<b>Docket Number:</b>	18-IRP-01
<b>Project Title:</b>	Integrated Resource Plan
<b>TN #:</b>	229409
<b>Document Title:</b>	Staff paper - Review of Roseville Electric Utility's 2018 Integrated Resource Plan
<b>Description:</b>	N/A
<b>Filer:</b>	Harinder Kaur
<b>Organization:</b>	California Energy Commission
<b>Submitter Role:</b>	Commission Staff
<b>Submission Date:</b>	8/13/2019 3:44:00 PM
<b>Docketed Date:</b>	8/13/2019

# **Review of Roseville Electric Utility's 2018 Integrated Resource Plan**

August 2019 | CEC-200-2019-011

**Figure 1: Roseville and Energy Commission Energy Demand Forecasts 2019-2030 (GWh)**

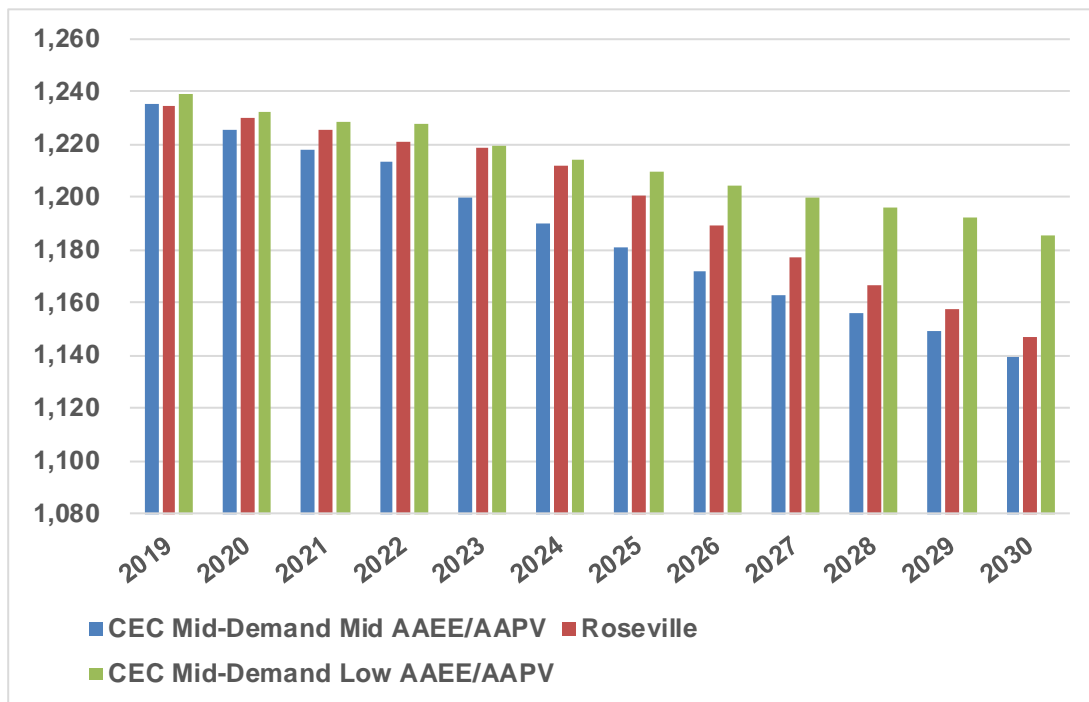
A comparison of Roseville's energy forecast with the Energy Commission's forecasts for Roseville is presented in **Figure 1**.<sup>10</sup>

**Figure 2: Roseville and Energy Commission Peak Forecasts 2019-2030 (MW)**

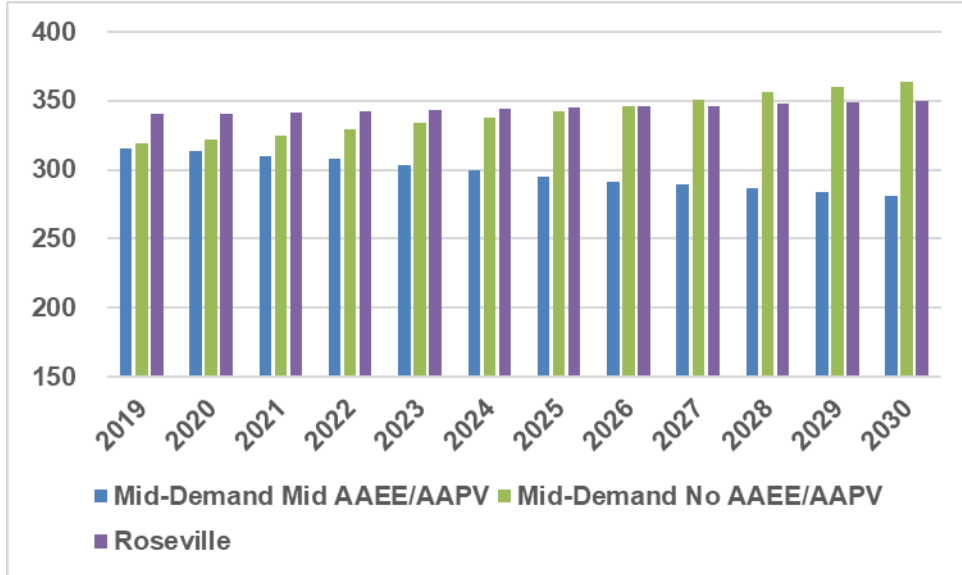
A comparison of Roseville’s annual peak demand forecast for 2019 to 2030 and that of the Energy Commission can be found in **Figure 2**. Roseville does not factor AAEE

savings into its peak load forecast. Roseville’s forecast is fairly consistent with the Energy Commission’s Mid-Demand No-AAEE/AAPV forecast, although the Energy Commission’s forecast is slightly lower in the early years and slightly higher in the later years of the forecast. The Mid-Demand Mid AAEE/AAPV is substantially lower than Roseville’s forecast, which is expected since it does include the savings from AAEE.

**Figure 4: Roseville Renewables Portfolio Standard Renewable Portfolios in 2019 and 2030**

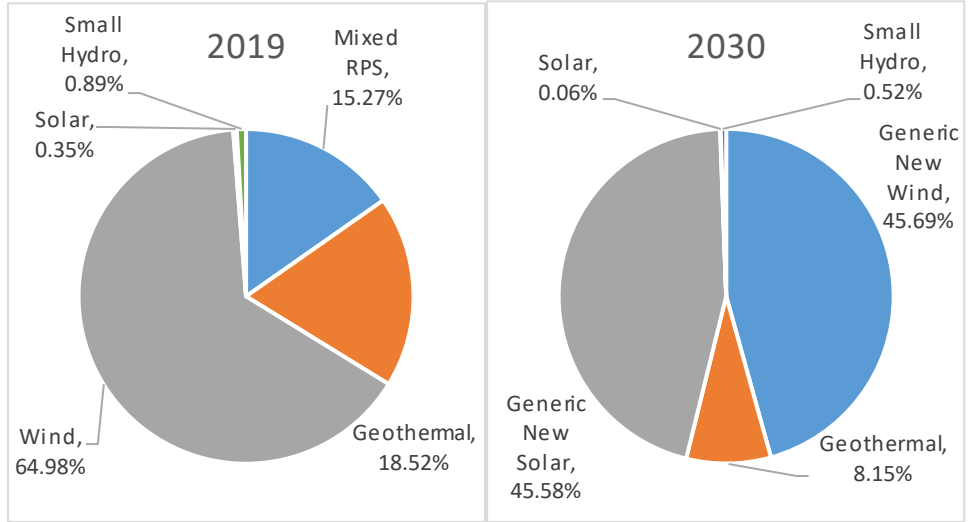
**Figure 4** below shows that Roseville’s renewable portfolio consists of 65 percent wind and 19 percent geothermal in 2019, then shifts to 46 percent wind and 46 percent solar in 2030. For detailed information regarding Roseville’s procurement of energy and RECs to meet the RPS see the energy balance table and RPS procurement table in **Appendix B**.

**Figure 5: Roseville Portfolio Comparison for 2019 and 2030 (MWh)**

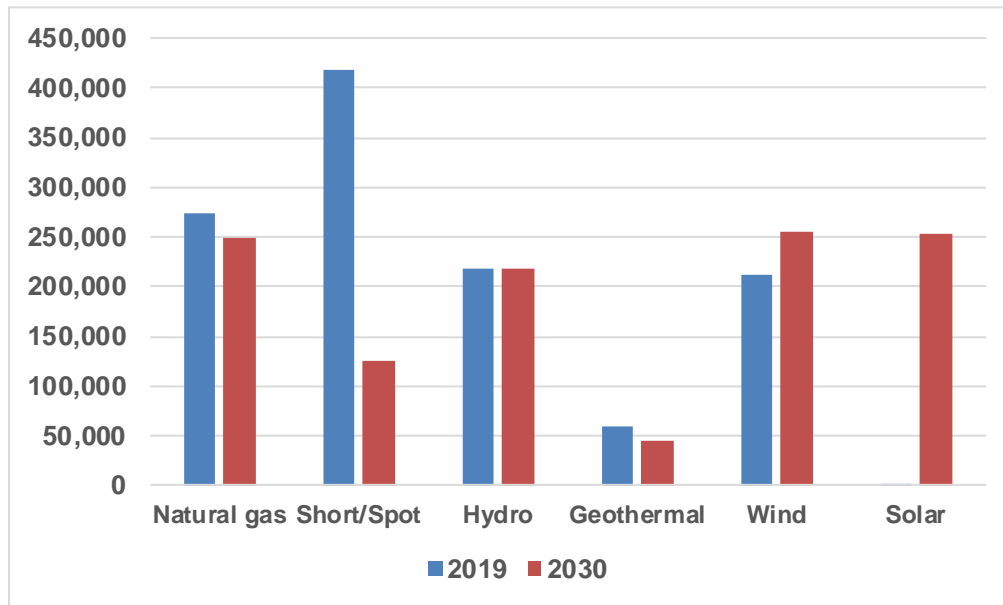
**Figure 5** shows a comparison of the energy mix of Roseville’s portfolio in 2019 and 2030. Roseville’s portfolio retains its diversity through 2030, while adding solar technology and preserving opportunities to procure resources outside the BANC balancing area.
